**OceanView at Cumberland, Tuttle Road, Cumberland
Revised Preliminary Subdivision Plan Submittal –*ADDENDA-1A*
(Map R04 Parcels 4B, 4D, 4E and 5)**

Subject: Peer Review of OceanView At Cumberland
Major Subdivision and Site Plan Application – Preliminary Review
Tuttle Road, Cumberland, Maine

Subject: Peer Review of OceanView At Cumberland
Preliminary Stormwater Review for Major Subdivision and Site Plan Application
Tuttle Road, Cumberland, Maine

Arch Culvert 2 PROFILE

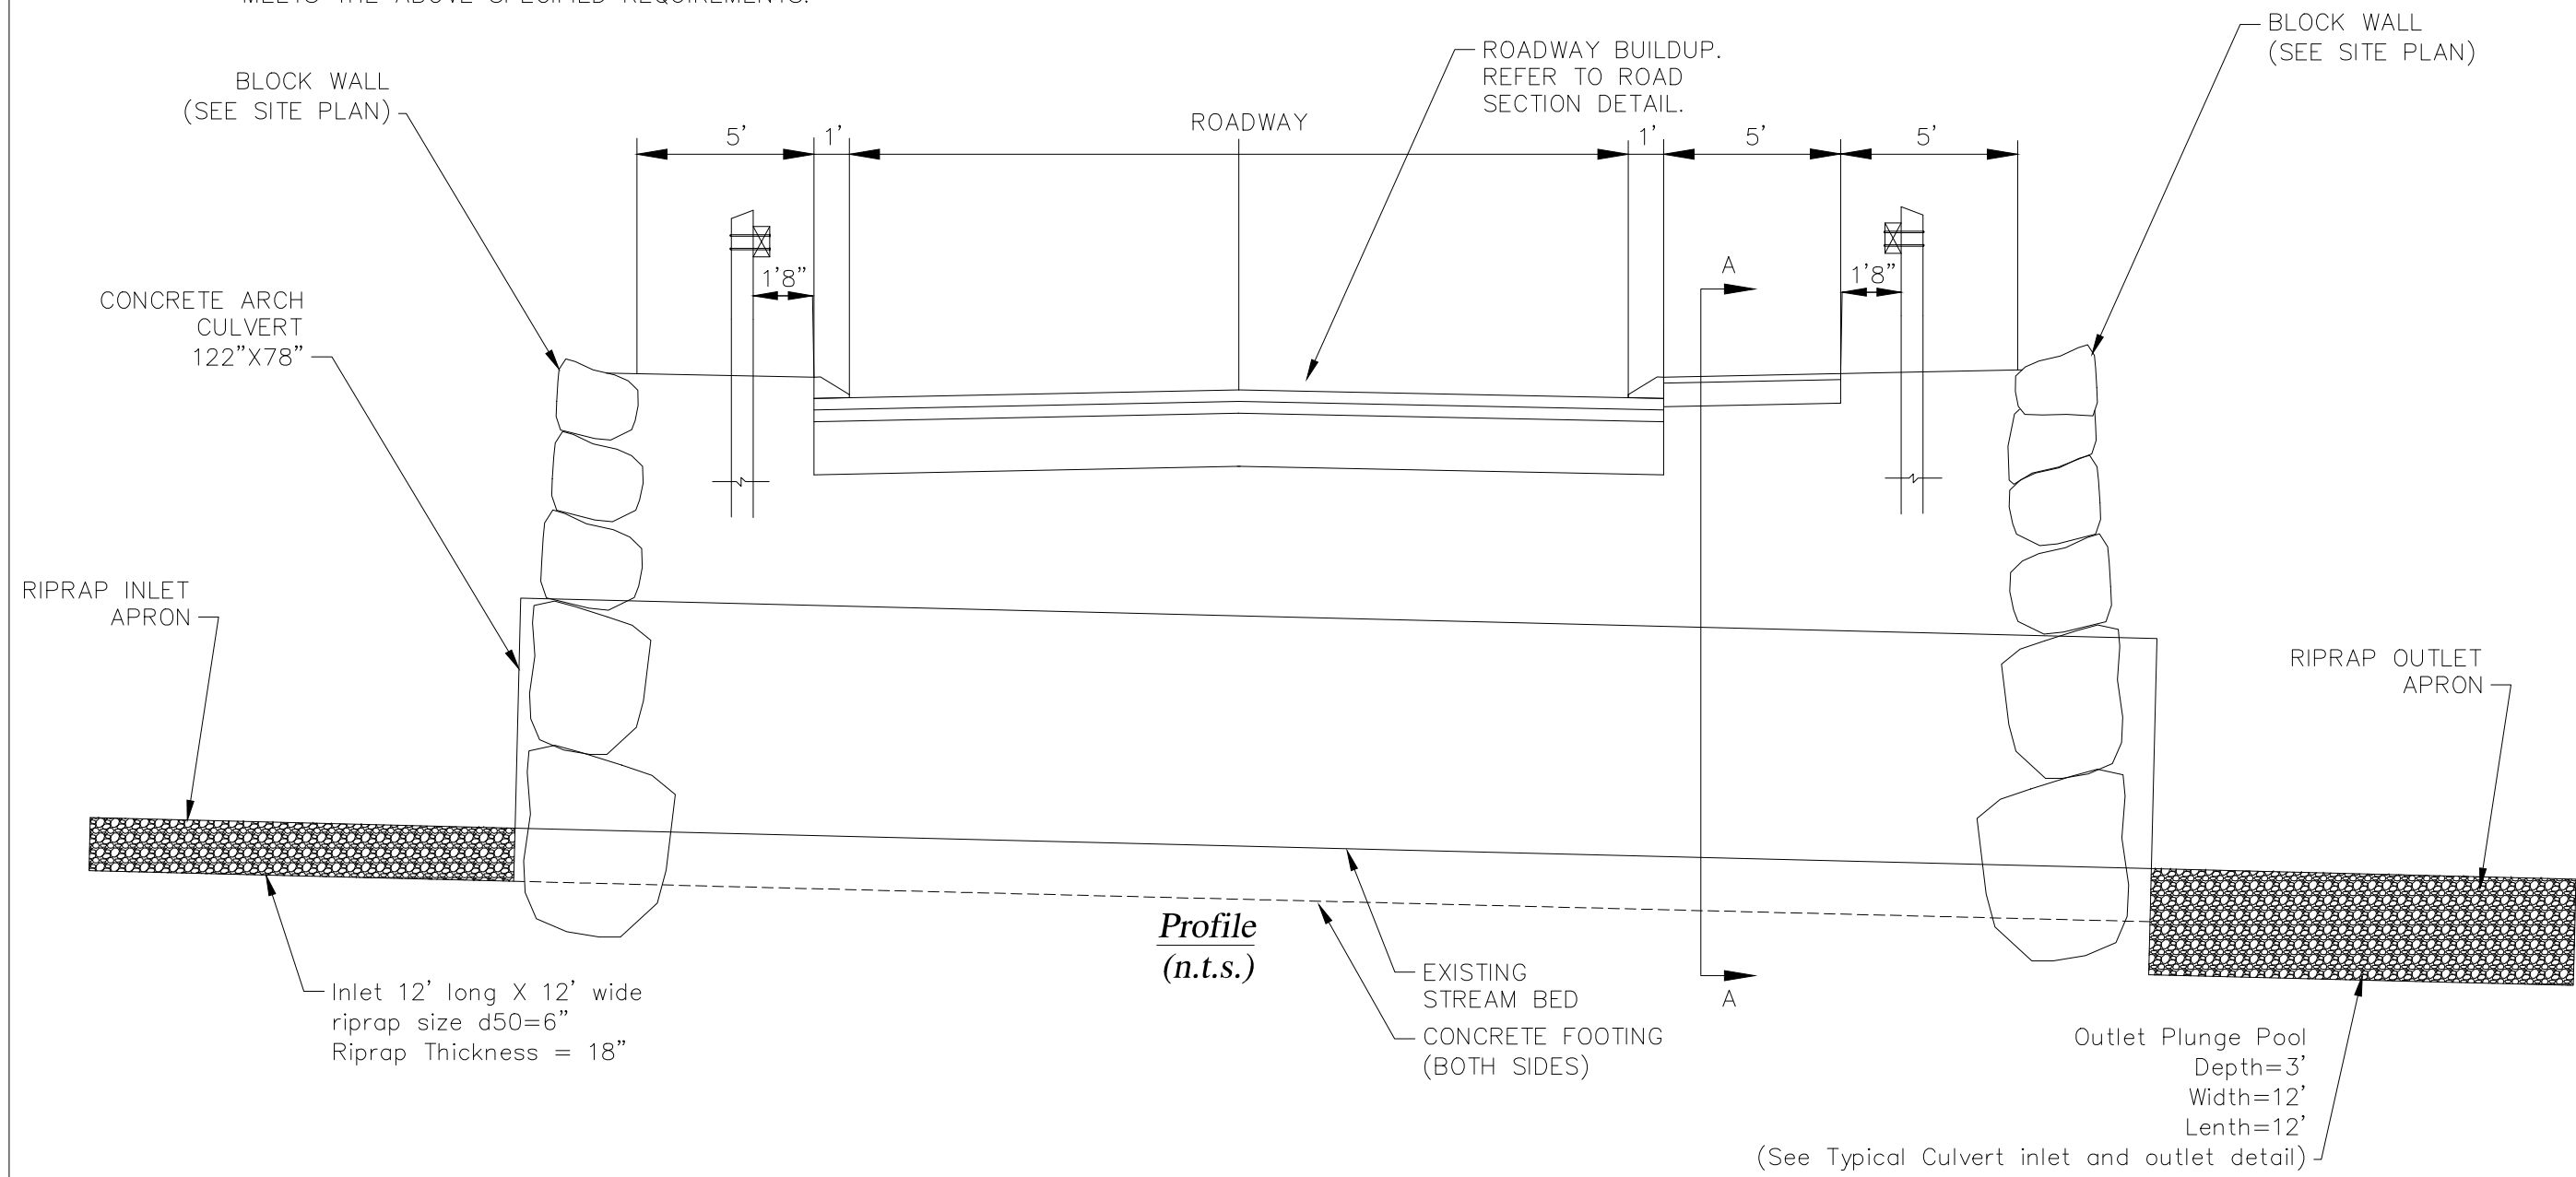
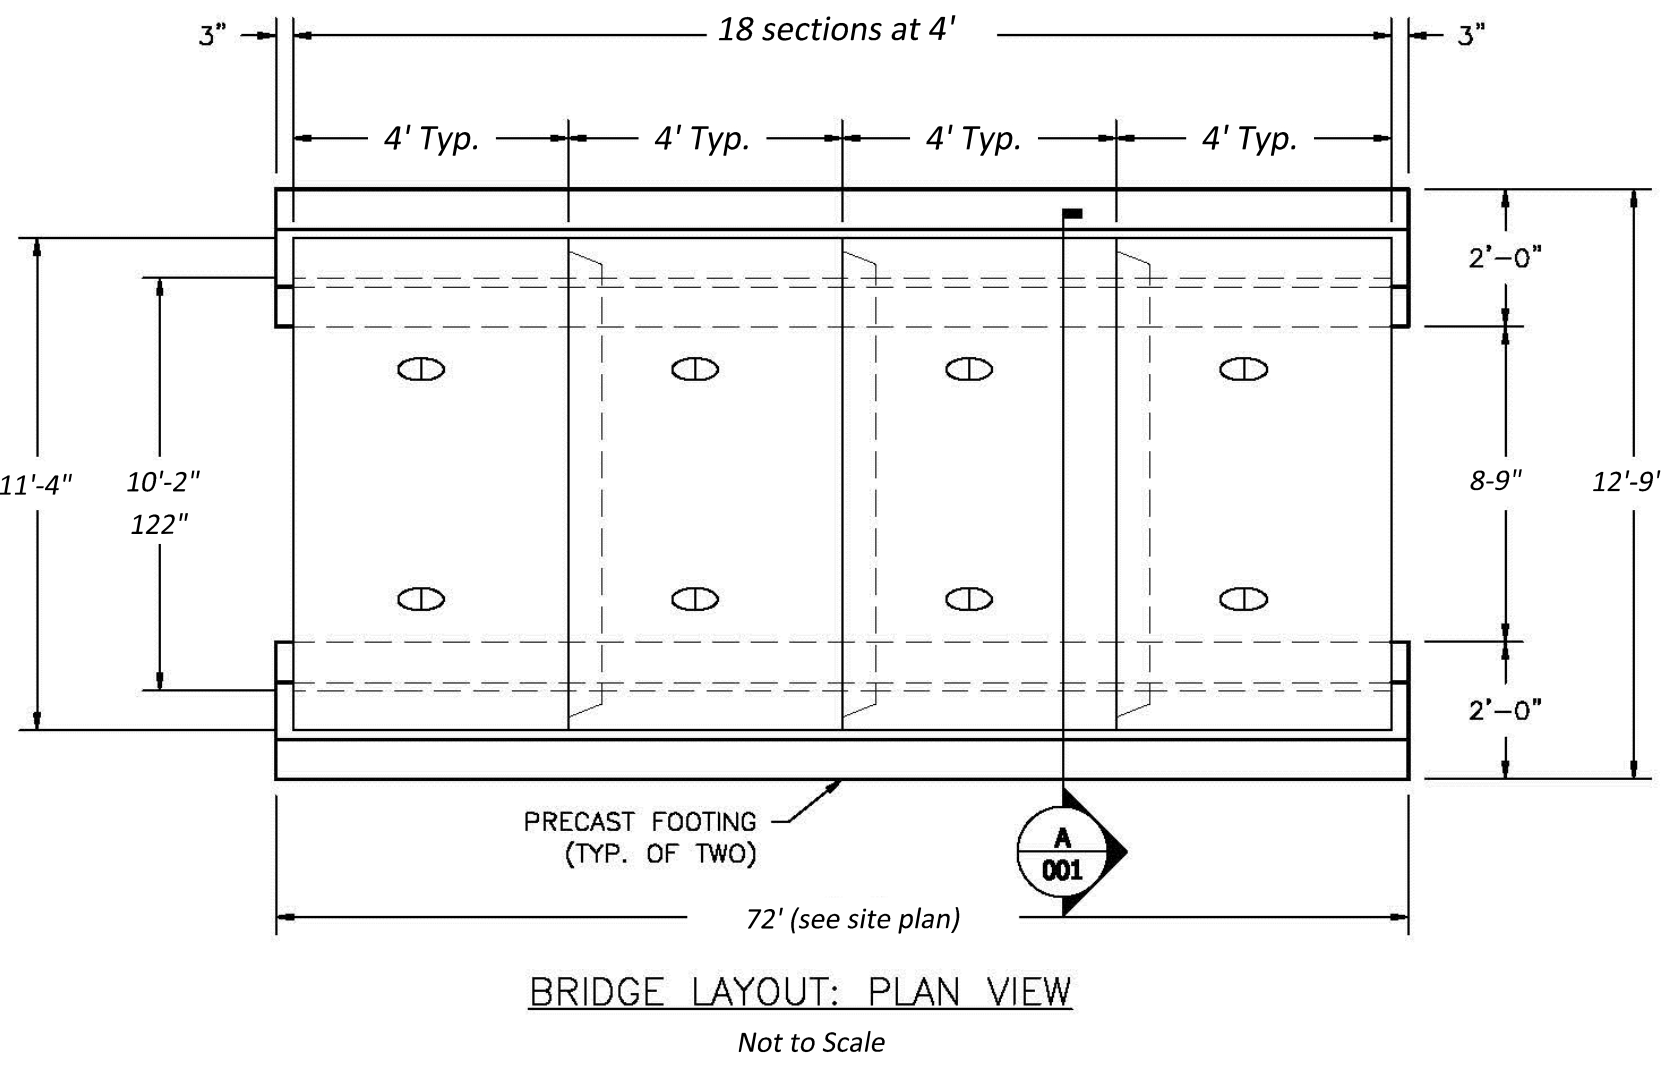
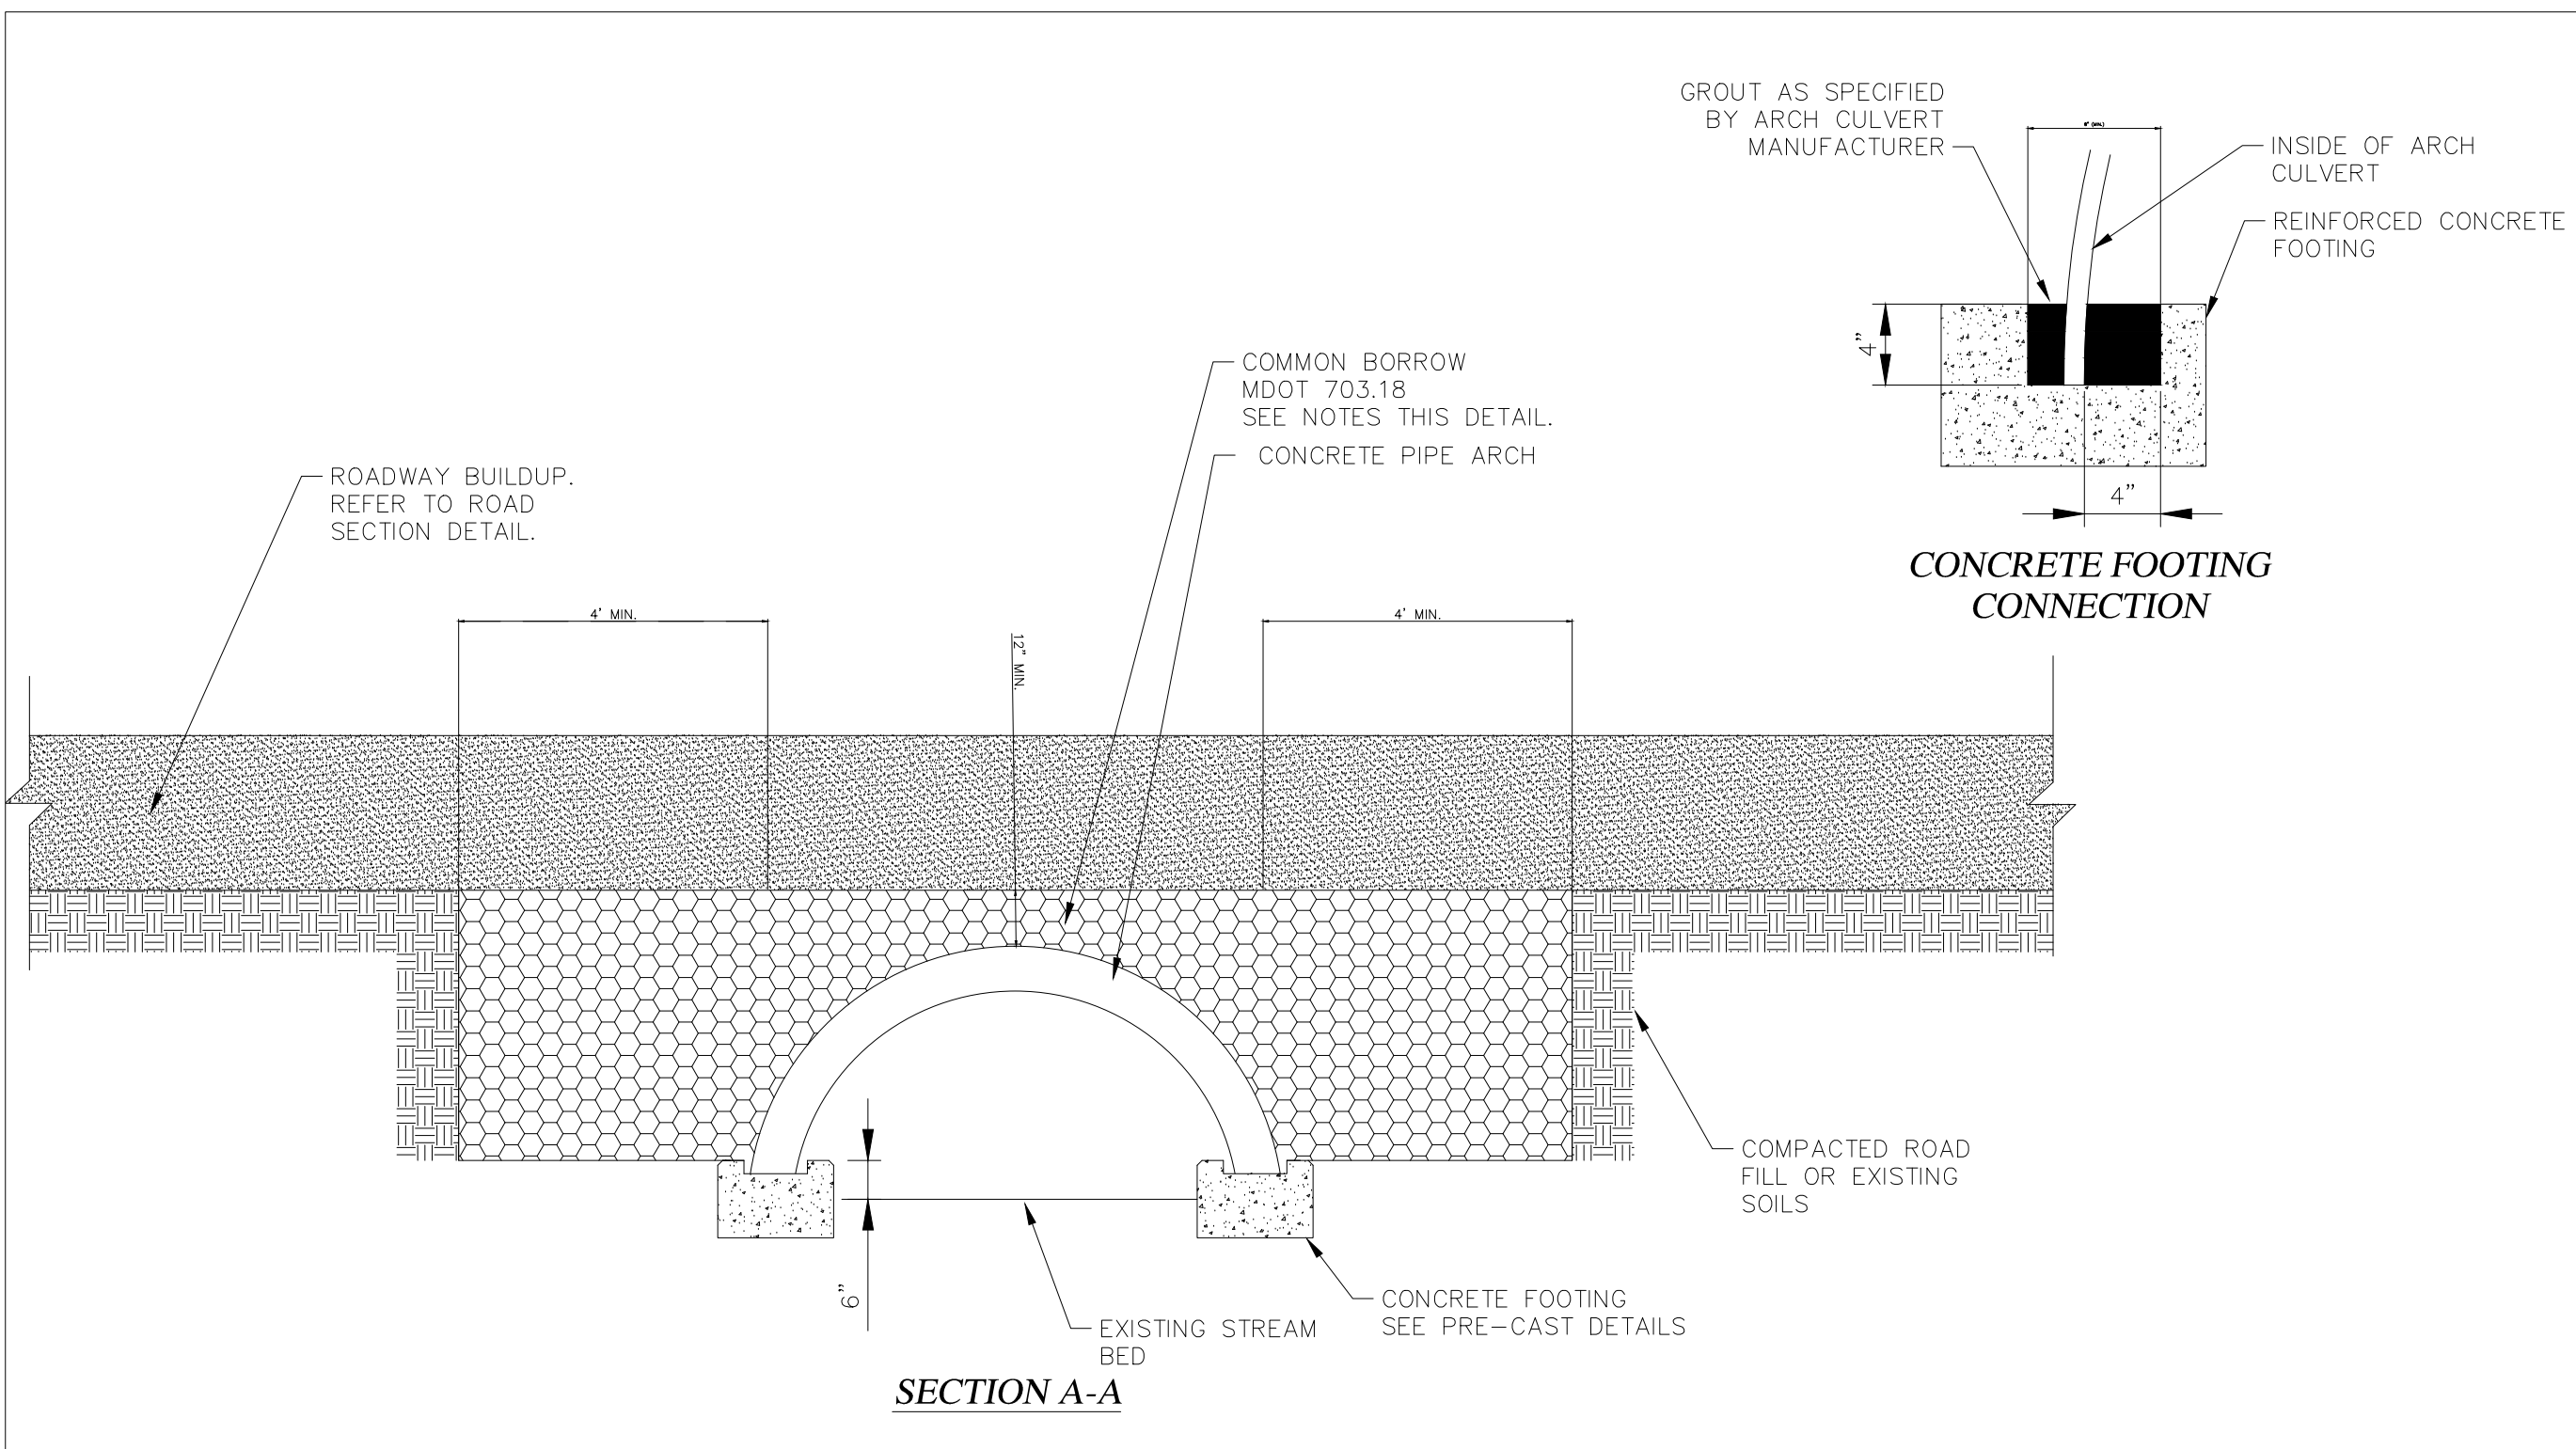
39. Arch 2 Culvert Details C21 - Profile does not include a sidewalk. SME recommends the applicant update the plan to reflect proposed construction. *The culvert details and sizing have been revised (100 year storm design). It should be noted that final construction details will be provided for final plan submittal pending agency reviews.*
